REPORT ON THE SPORT FISH RESOURCES OF THE NORTH THORNE RIVER SALE UNIT AND RECOMMENDATIONS FOR THEIR PROTECTION DURING LOGGING OPERATIONS

RICHARD D. REED

ALASKA DEPARTMENT OF FISH AND GAME

JUNE 15, 1972

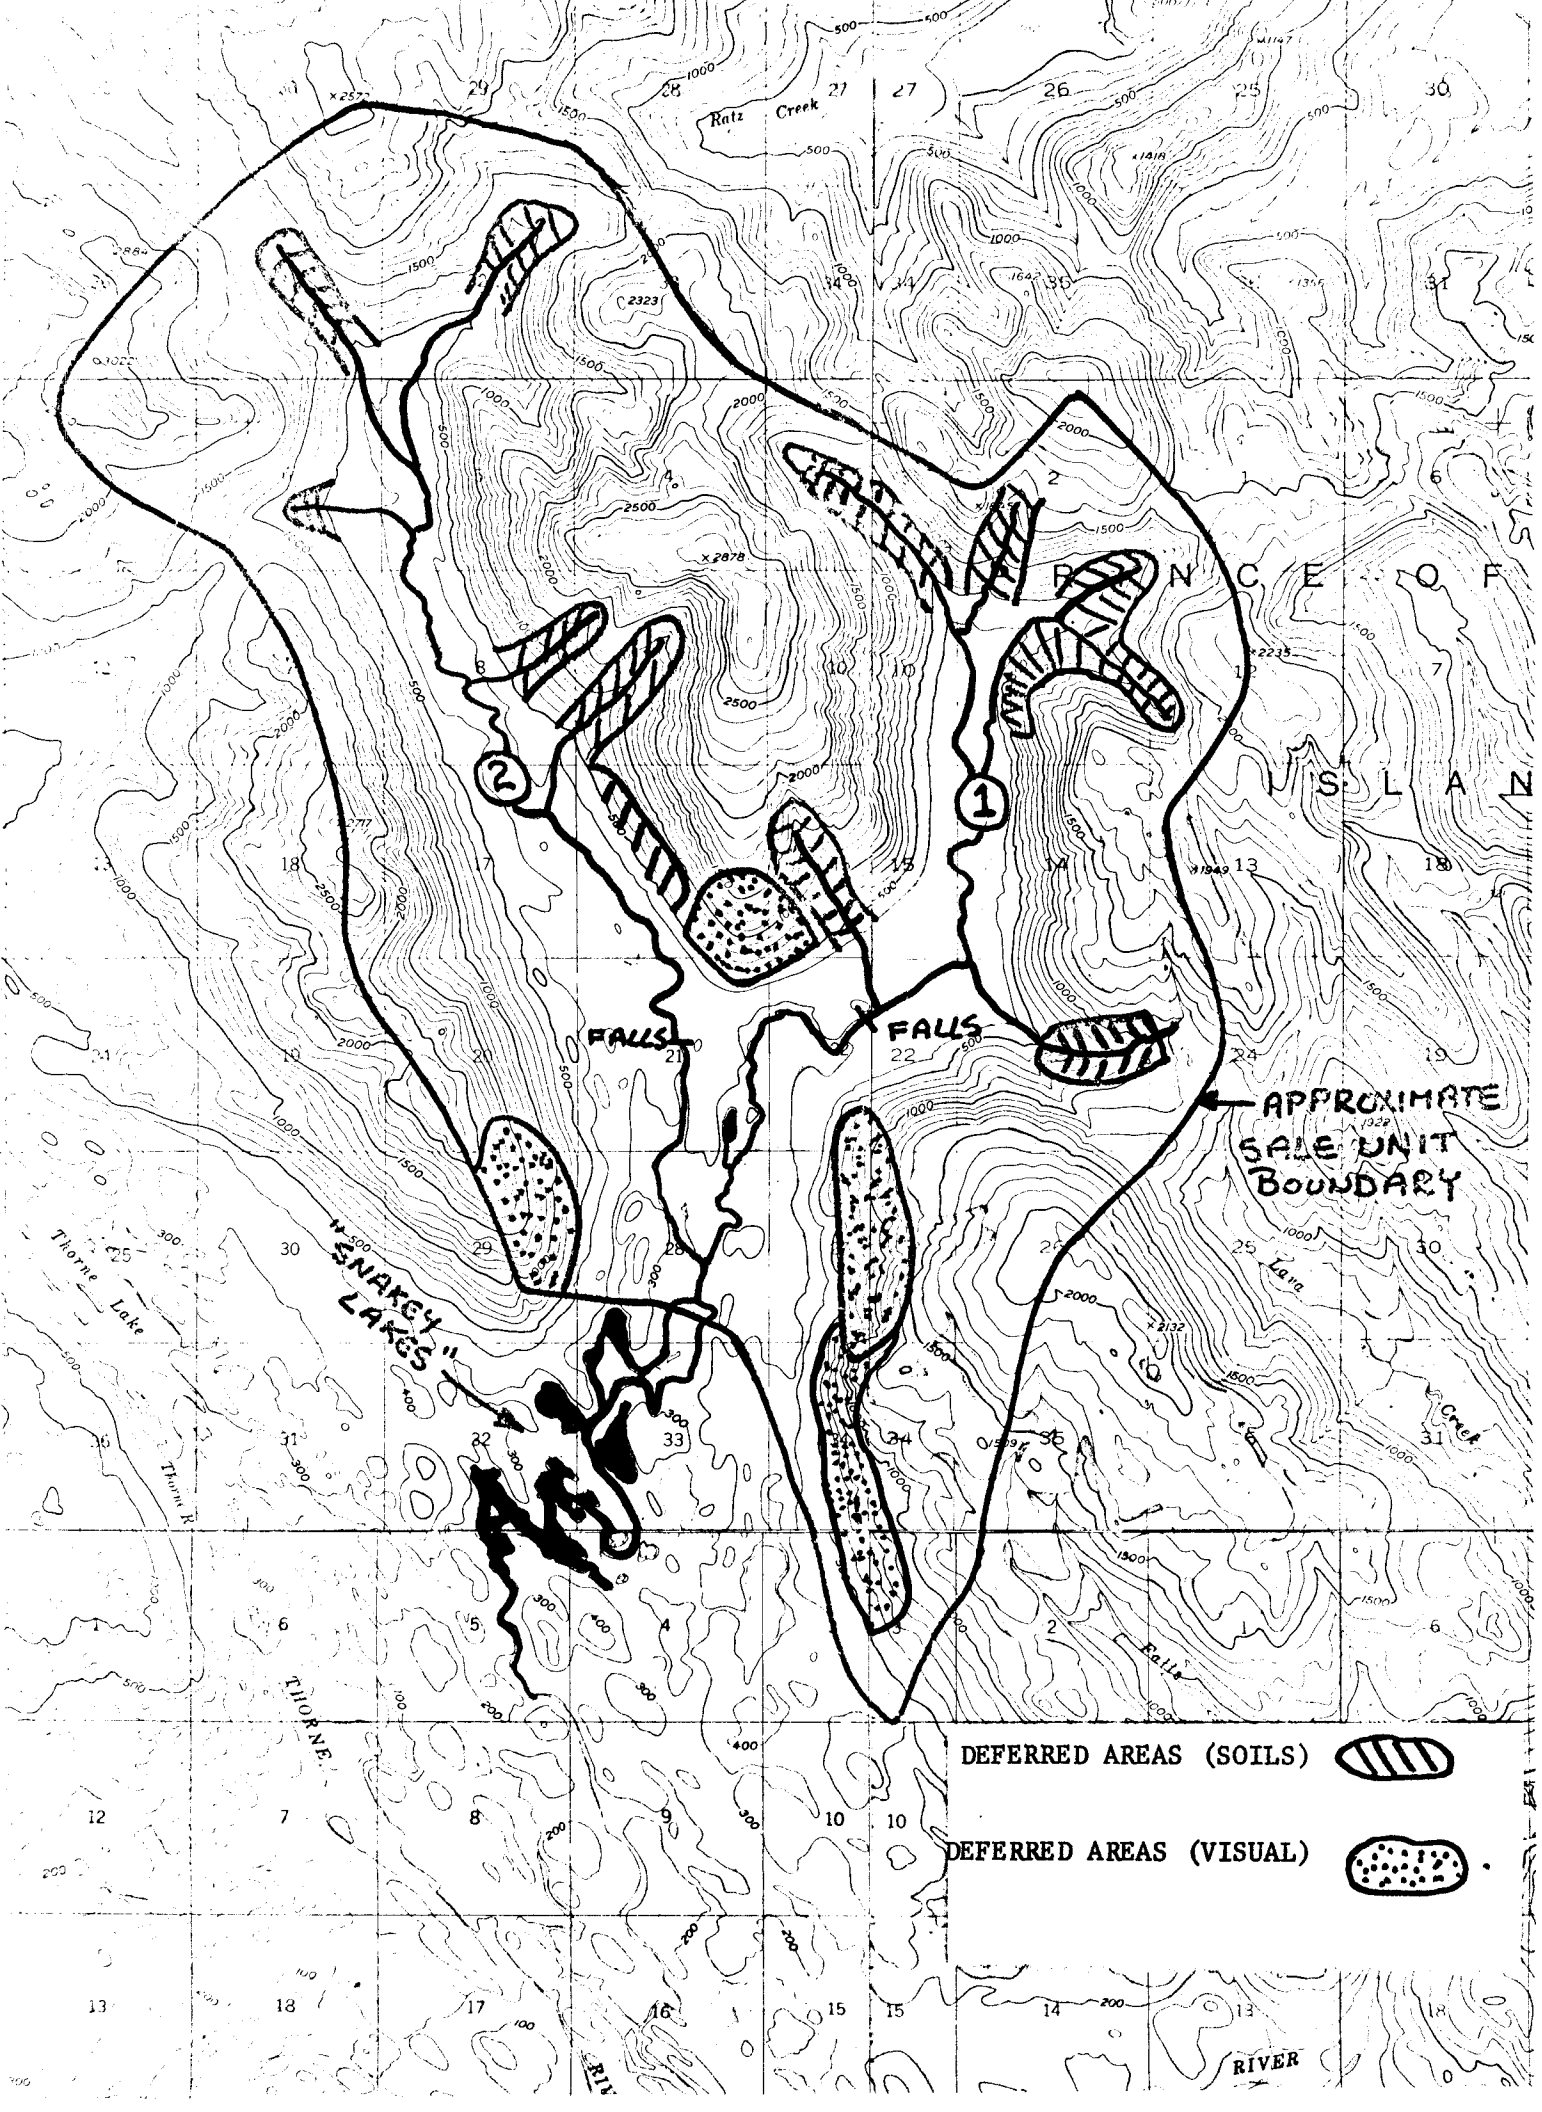
(1) Although much of the stream channel lies along the center of the valley floor and is thus somewhat protected from slides, there are sections which approach the walls. If the soils are found to be unstable, these areas (see map) should be deferred from logging until such time as techniques are developed which would allow timber harvest on slide prone areas with little or no risk of slides.

(4) If timber harvest is permitted along the main fork or any of its tributaries, trees should be felled and yarded away from the streams to protect the physical integrity of the banks and stream bottom. How about Leave Strip?

(5) Some sections of the valley are visible from the "Snakey Lakes." Since these lakes have an extremely high recreational potential, considerable care should be taken concerning the visual impact of timber harvest on them from within this unit. If the areas indicated (see map) are found to have a visual impact on the lakes, logging should be deferred until such time as techinques are developed which permit timber harvest without visual disturbance. No clear-cut!

Is this a valid Reason?

Is Somebody going to abide by our rules and log on slopes Steeper Than 35%?

Was there a Wilderness Area Study done on this as per Cliff's direction?
